**Re:** A-Tech Security  
**4616 Hawkins NE**  
**Traffic Circulation Layout**  
Engineer's Stamp dated 07-07-16 (D17D104)

**Re: A-Tech Security  
4616 Hawkins St., NE  
Traffic Circulation Layout  
Engineer's/Architect's Stamp dated 5-25-16 (D17-D104)**

**Re: Nelson-Hawkins Lot #16-A(1)**  
**4616 Hawkins St., NE**  
**Traffic Circulation Layout**  
Engineer's/Architect's Stamp dated 11-16-15 (D17-D104)

RE: **A-Tech Security**  
**Grading & Drainage Plan**  
**Engineer's Stamp Date 5-25-2016 (File: D17D104)**

Figure 1. Mini Clear Sight Triangle

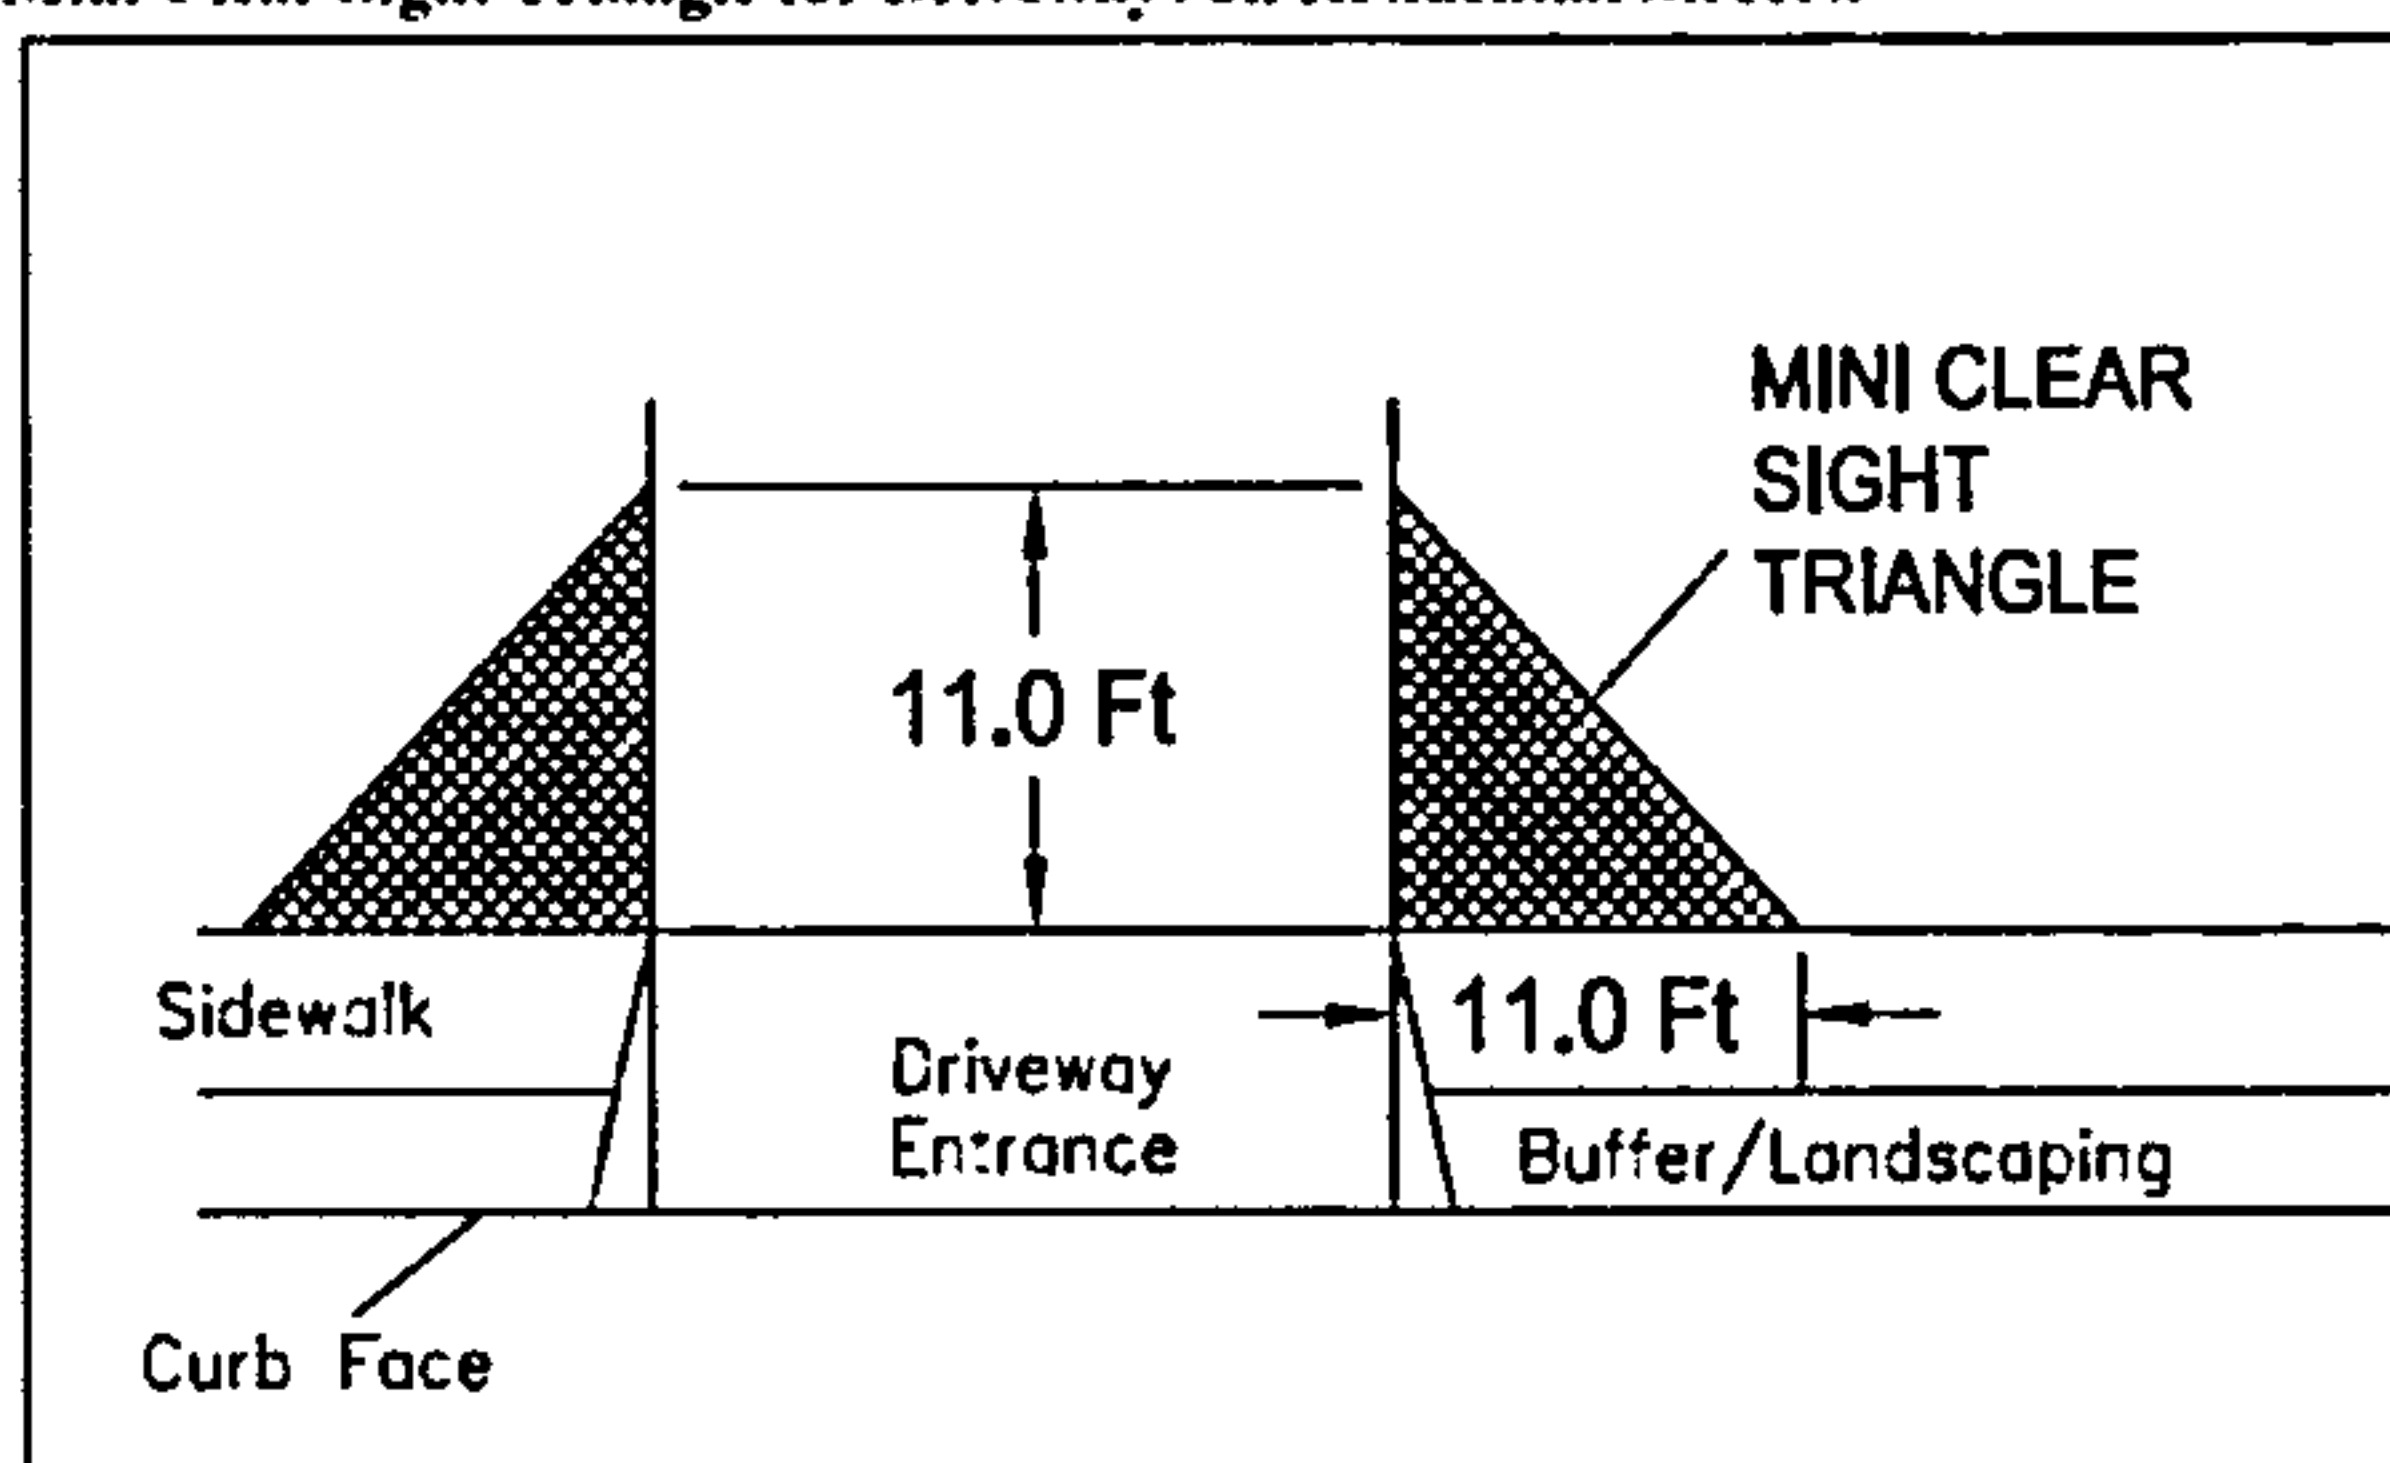
7. Please provide a sight distance exhibit (see the *Development Process Manual, Chapter 23, Section 3*). Please show this detail for the entrance/exit on Hawkins St.

Mini Clear Sight Triangle for Driveways on Residential Streets:
